JERSEY CENTRAL POWER & LIGHT COMPANY
OYSTER CREEK NUCLEAR GENERATING STATION

Application for a Full Term License

DOCKET NO. 50-219
SUPPLEMENT NO. 5
to
AMENDMENT NO. 68

This Supplement to the Application for a Full Term License for the Oyster Creek Nuclear Generating Station is in response to the April 3, 1973 letter concerning the cask drop protection system, proposed by the applicant to mitigate the consequences of the postulated cask drop accident, and includes additional information presented to members of the Regulatory Staff at a meeting on March 16, 1973.

CROSS SECTION THROUGH UPPER GUIDE CYLINDER
 FIGURE 1

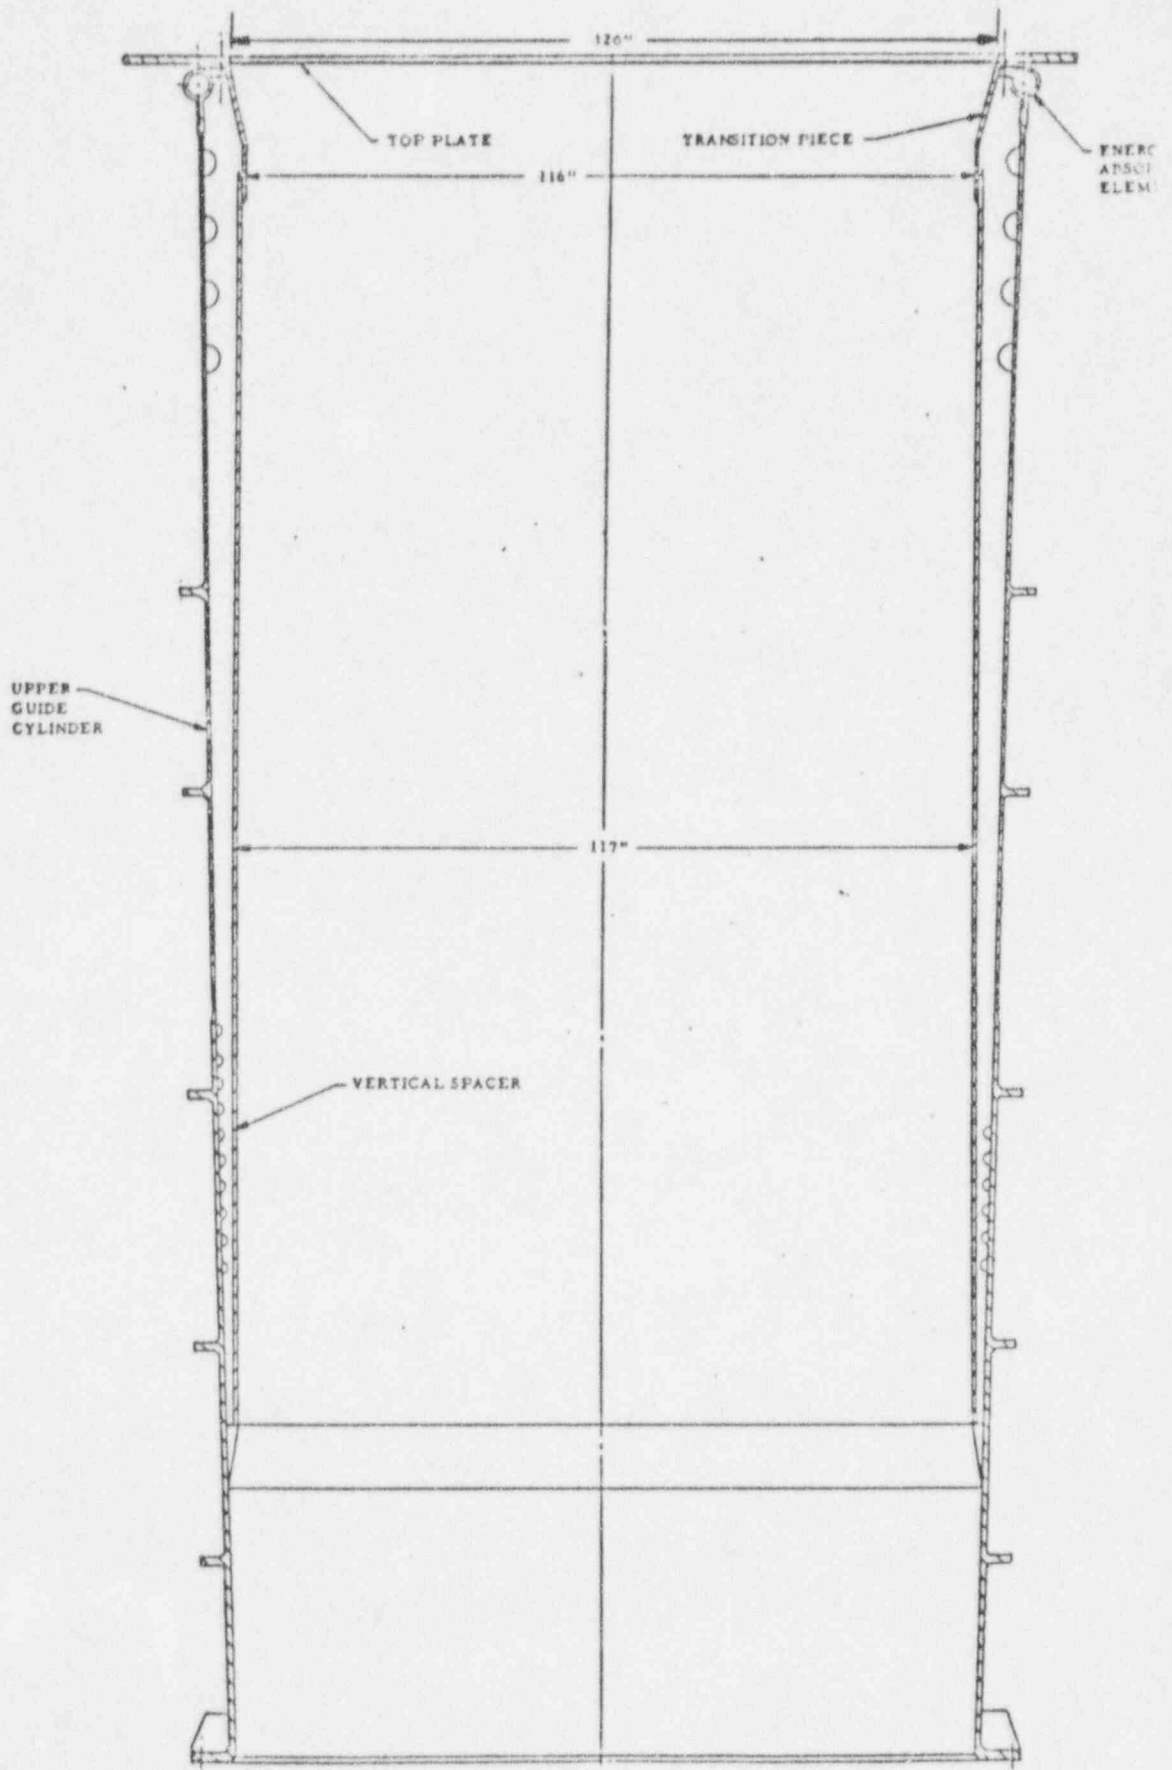
The opening in the top plate has been increased from 116 inches to 120 inches as shown in Figure 1. As a result of this change, the minimum diametral clearance for inserting the 110-inch diameter cask base plate into the cask drop protection system is increased from 6 inches to 10 inches. The effective diametral clearance is 12 inches when chamfers on the plates are considered. Tapered transition pieces are provided between the 120-inch diameter opening in the top plate and the 117-inch effective diameter inside the upper guide cylinder. All other details of the upper guide cylinder are the same as described in previous submittals (i. e., Supplement Nos. 1 and 2). Since the portion of the upper guide cylinder affected by this change is above the water level of the spent fuel pool, this change will have no effect on the hydraulic performance of the cask drop protection system as presented in Supplement Nos. 1 and 2.

FIGURE 2

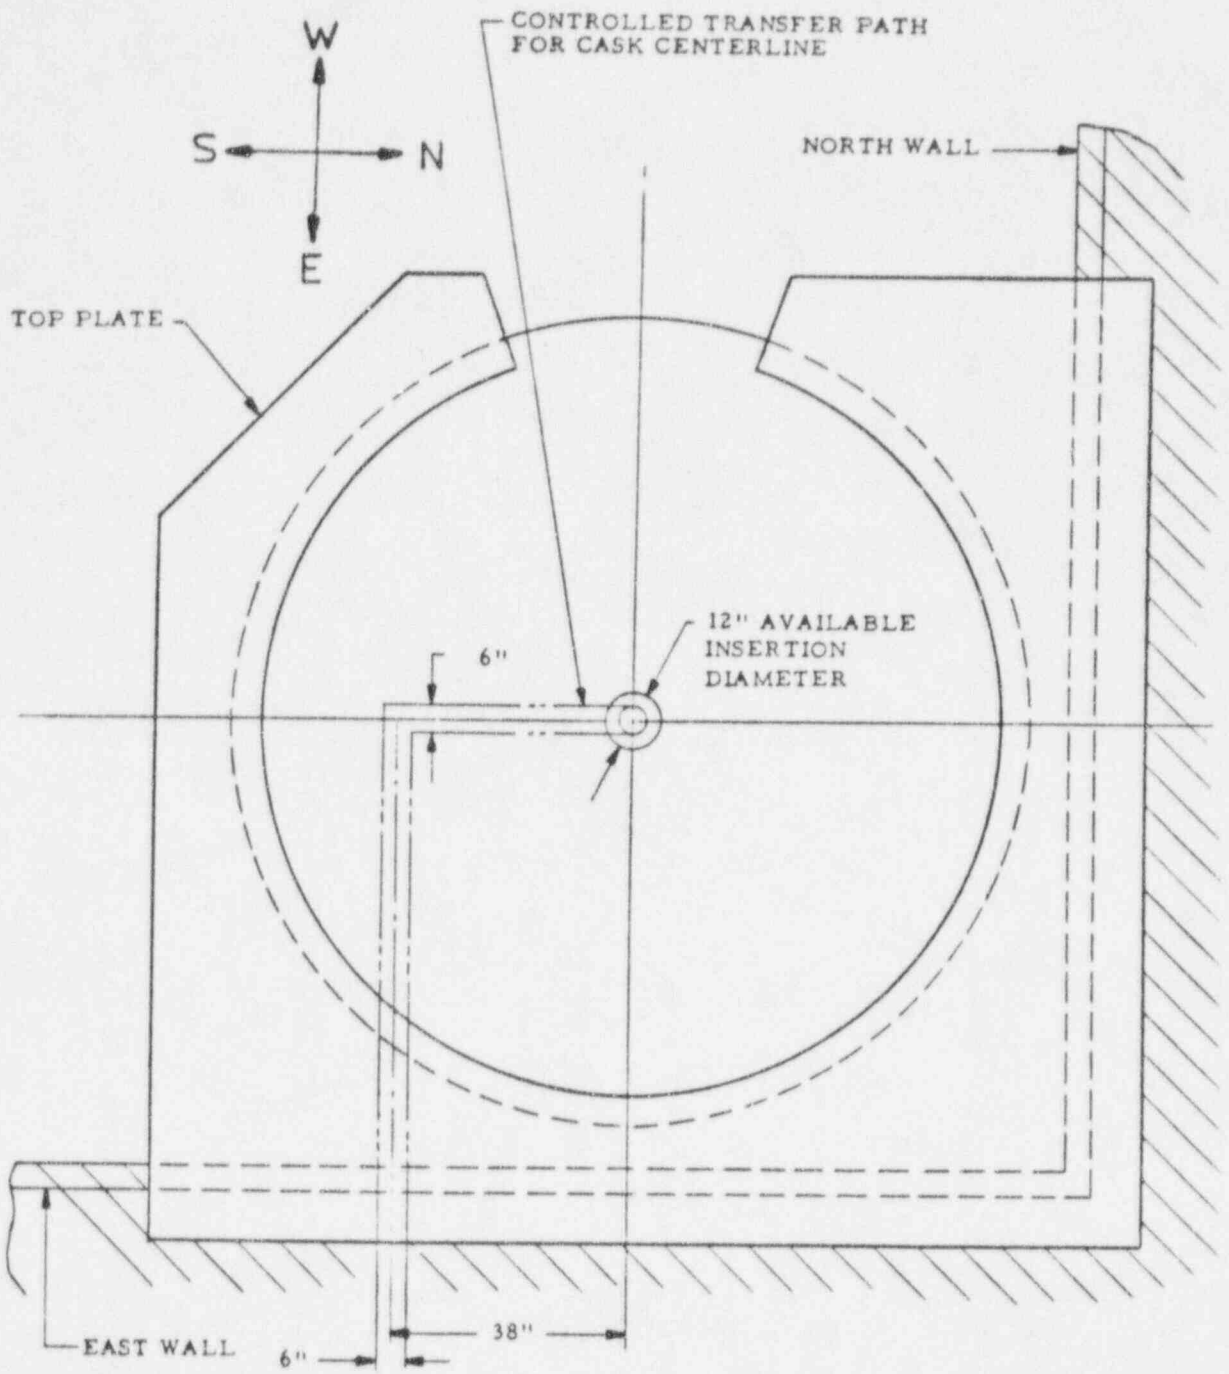
The transfer path for the cask centerline to be used in conjunction with the 120-inch diameter opening in the top plate is shown in Figure 2. The controlled path width of 6 inches for cask travel in the north-south and east-west directions is the same as indicated in Supplement Nos. 1 and 2. As shown in Figure 2, the location of the cask centerline will be controlled within a 6-inch diameter circle during the approach of the cask to the center of the upper guide cylinder. This

provides a margin of 3 inches in all directions between the controlled insertion diameter of 6 inches and the available insertion diameter of 12 inches. Visual aids consisting of guide lines and/or light weight guide fences as indicated in Figure III-4 of our September 29, 1972, report, transmitted as part of Supplement No. 1, will be used to control the motion of the cask centerline to the prescribed transfer path. In addition, in response to condition 6 of Mr. Skovholt's letter, mechanical rail stops will be installed to prevent overtravel of the crane during cask transfer operations. Stops will be mounted on the bridge rails to prevent crane overtravel in the north and south directions and on the trolley rails to prevent overtravel in the west direction.
